SERVICETEKNOTES

TABLE OF CONTENTS

ANSWER SERVICE BULLETIN #22

DC510/DC5010 INTERMITTENT OPERATION

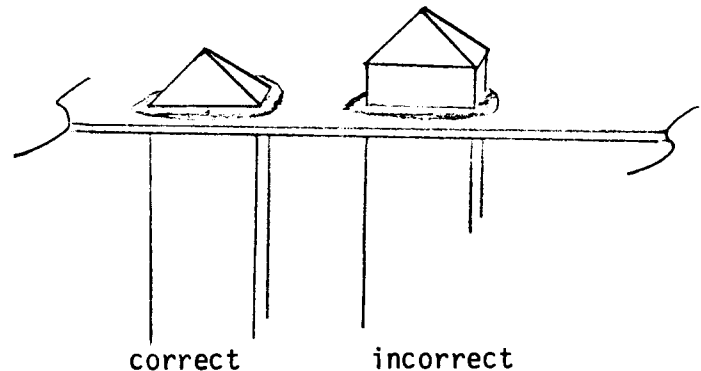
Intermittent operation of the counter can result when the pins of J1102 (A12) work loose at P1102 on the A18 auxiliary board. Manufacturing, on some instruments, failed to solder the pins of J1102 correctly to the board. The illustration shows correct positioning of the pins, with the pyramidal top just showing,

as compared to the incorrect positioning with too much of the shaft pushed through the board. The result of too much shaft pushed through the board is the pins of J1102 (A12) working away from their connection at P1102 of (A18) causing intermittent operation, and possibly a 313 serial path error.

Recommended repair of J1102 is replacement of the pins with a new set (pulling out and replacing the pins is easier than realigning the old pins).

Modifications:

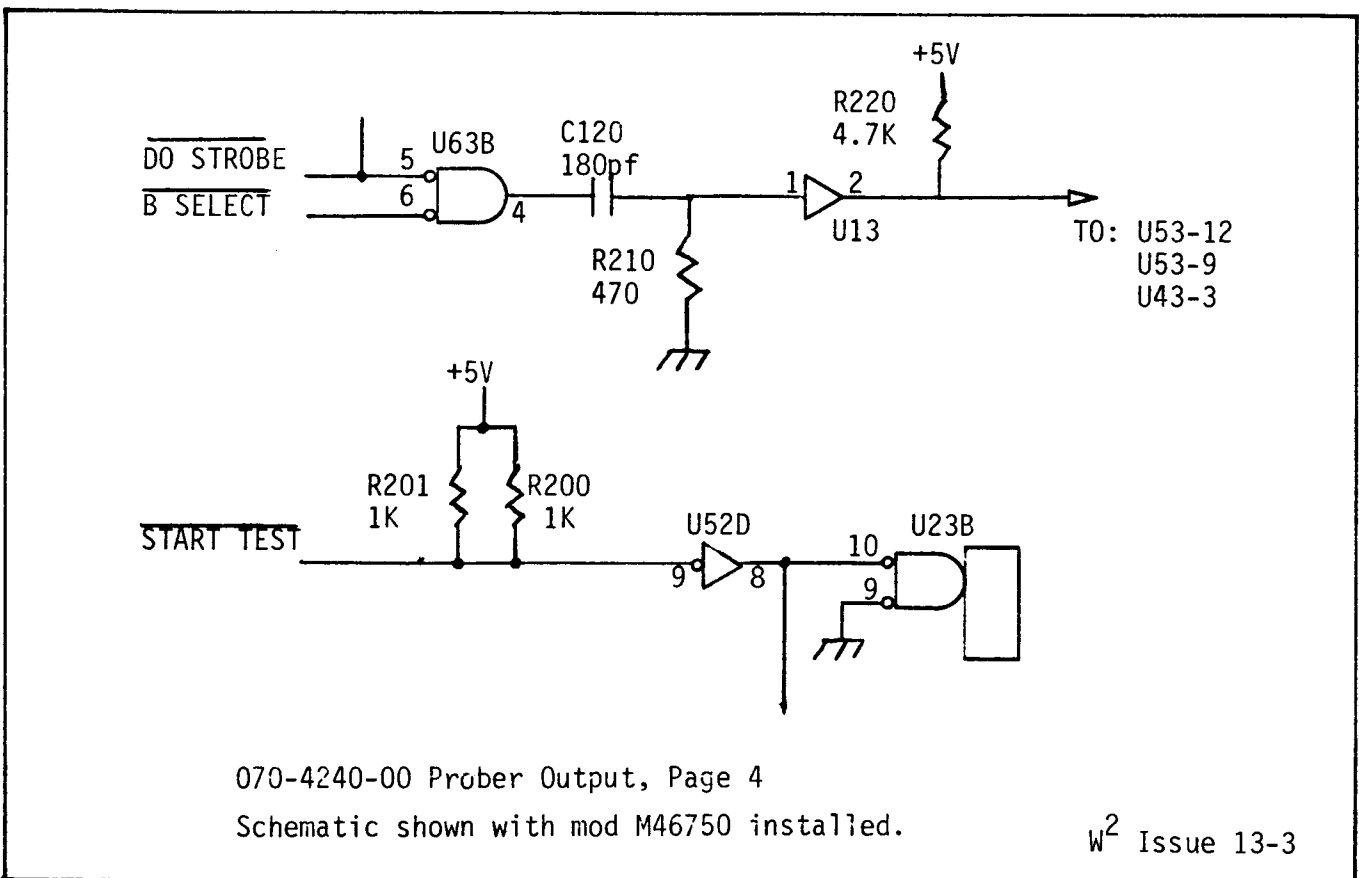
1. X address information overwrites Y address information causing incorrect wafer placement when operating in the Option 658 mode.
2. The Test System will intermittently cycle to "INTEST" when the handler is powered off.

All modifications are done to the backside of the TAC PR100 Prober Output IF Circuit Board. The board P/N 670-5654-00 changes to 670-5654-01 after the mod is installed.

1. Cut run between U63 pin 4 and U53 pin 9.
2. Add capacitor C120 (180PF, 283-0641-00) between U63 pin 4 and U13 pin 1.
3. Add resistor R220 (4.7K, 315-0472-00) between U13 pin 14 and U13 pin 2.
4. Add resistor R210 (470 ohm, 315-0471-00) between U13 pin 7 and U13 pin 1.
5. Add wire (0.4 ft., stranded, 26AWG, 9-0, 300V, from U13 pin 2 to U43 pin 3.
6. Add wire strap from R200 pin 8 to R201 pin 8. Use same type wire as in Step 5.

STEP 1 through 5 will shorten the X and Y load signals to 80 NS eliminating the problem of data changing state during an enabled condition.

STEP 6 will lower the value of R200 to 500 ohms. This will raise the voltage level and increase the noise immunity eliminating the cycle to "INTEST" when the handler is powered off.

TSG6 HI-LO RANGE FLATNESS

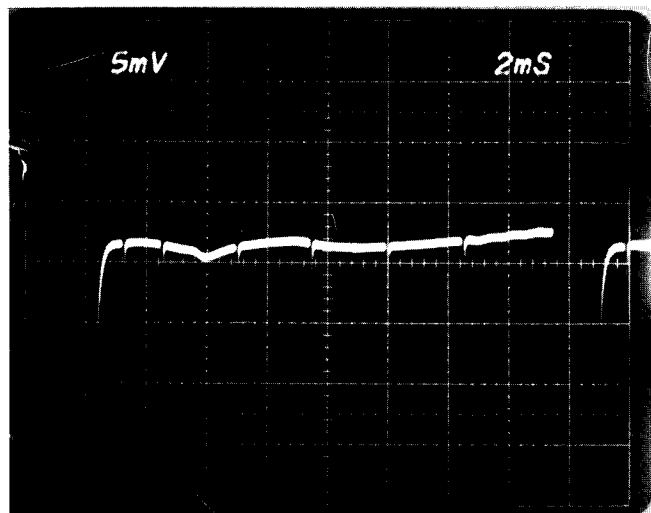
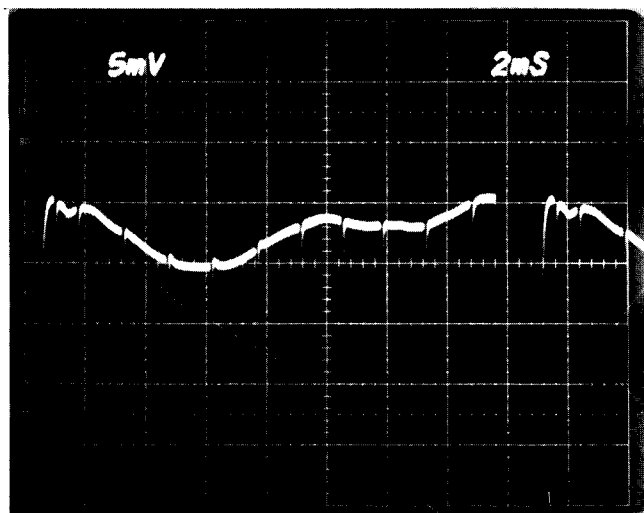
While calibrating the frequency response flatness of the TSG-6, some technicians have noticed that the waveforms are somewhat irregular. The two photos below show typical flatness waveforms. The irregularity is acceptable provided that the response specs are met in each case.

Equipment settings are:

1410 HI = 100IRE LO = 7.5IRE
 1411 HI = 100% LO = 0%
 067-1039-00 HI = WHITE LO = BLACK

NOTE: The 7.5IRE Flat Field from the 1410 is from Black Burst with setup. Black from the 067-1039-00 is obtained with all left hand side push-buttons out.

Figure A
Partial Schematic

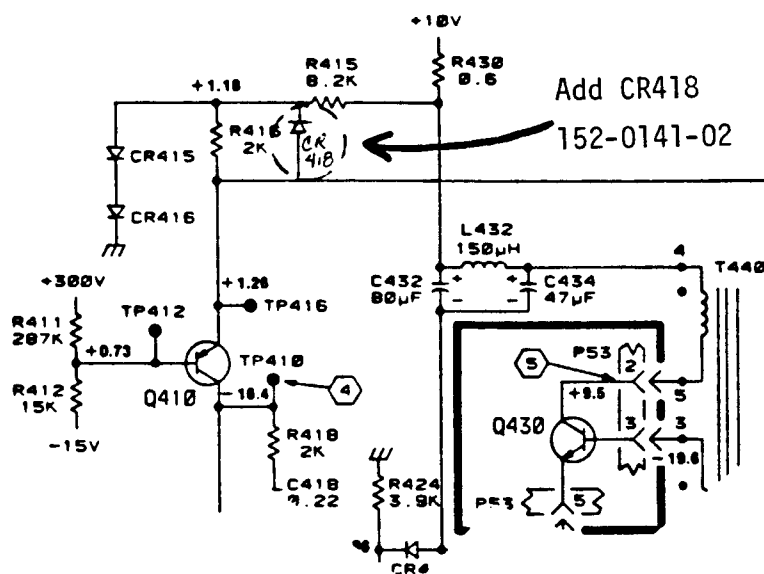
During high intensity operation, excessive beam current has caused Fuse F542 to beam.

Mod 49237 adds a catch diode (P/N 152-0141-02) to the circuit, and changes F542 to a 1 Amp fuse (P/N 159-0020-00). This will prevent failures of the fuse irregardless of where the screen intensity is set.

Add this mod (see Figure A) where this problem has occurred.

1450 SERIES SEMI-RIGID COAX

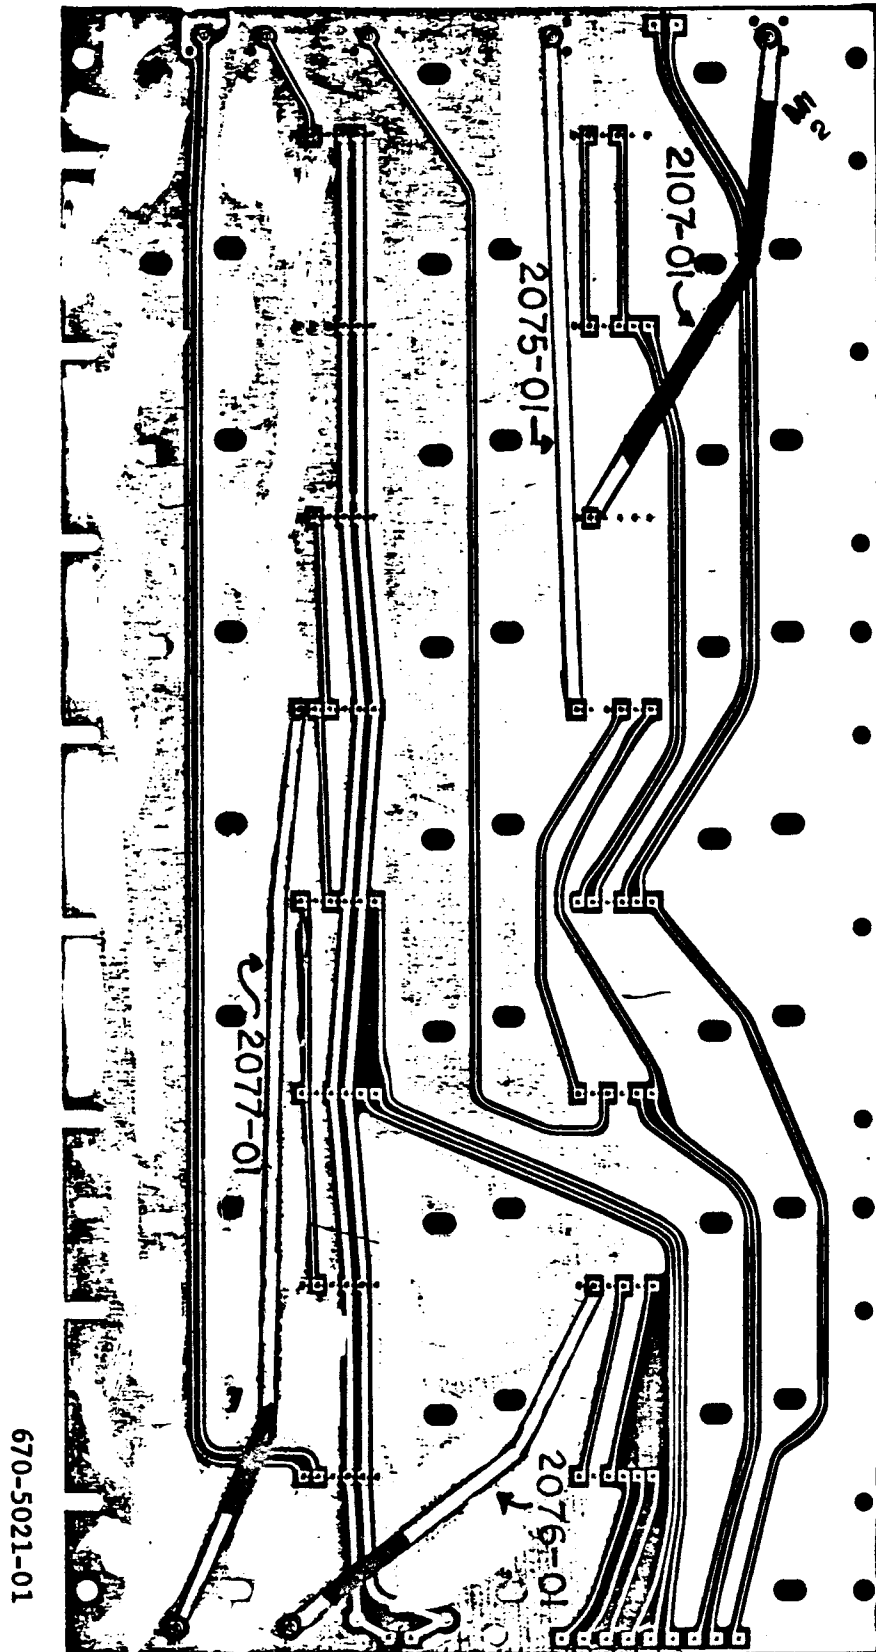
Mod 40160 changes the Phase Lock Interface board (670-5021-00) to a -01 version.

The main impact of this mod was to slightly lengthen the semi-rigid coaxial cables on the rear of the board, thereby insuring a better mechanical connection. The new cables are:

175-2075-01 1 ea
 175-2076-01 1 ea
 175-2077-01 1 ea
 175-2107-01 1 ea

The replacement of these cables is illustrated in the attached diagram.

The new numbers should be used when replacing the corresponding cable on an earlier board.
